Date Issued :	January 30, 2023	PCN Number :	513103
Reason for Change :	Change to Product		
Description of Change :	Correction in Product drawings to match sales drawings: no red cap, label distance corrected to REF 100mm, ends of wires should be stripped REF 10mm.		
Reason for Short Notice :	Corrective Actions		
Assessment of Change :	First Article Inspection		
Planned Implementation Date :	February 28, 2023		
Sample Availability Date:	February 15, 2023		
Internal Molex Qualification Date :	February 15, 2023		
Last date to request Samples by Customer :	February 01, 2023		
Traceability Code Markings / Date :	No special marking on the product or packaging

**Correction to Product drawings to match Sales drawings for standard receptacle products with engineering numbers: 1Rx000A39xxxx, 1Rx000A20xxxx and 1Rx004A20xxxx**

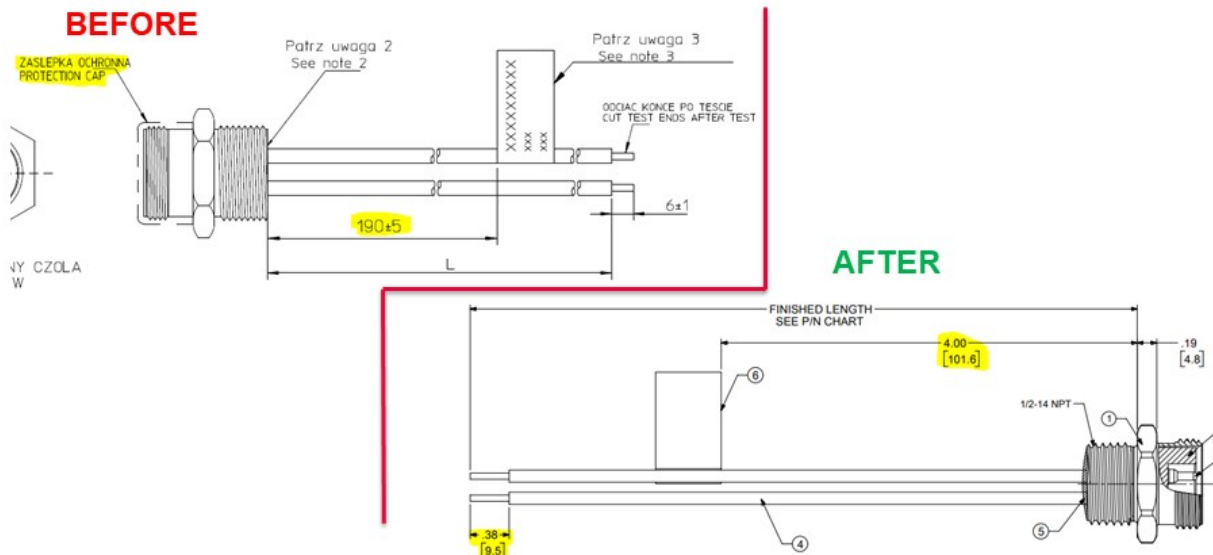
- No red cap needed for standard receptacle products. Label distance corrected to REF 100mm. Ends of wires should be stripped REF 10mm.
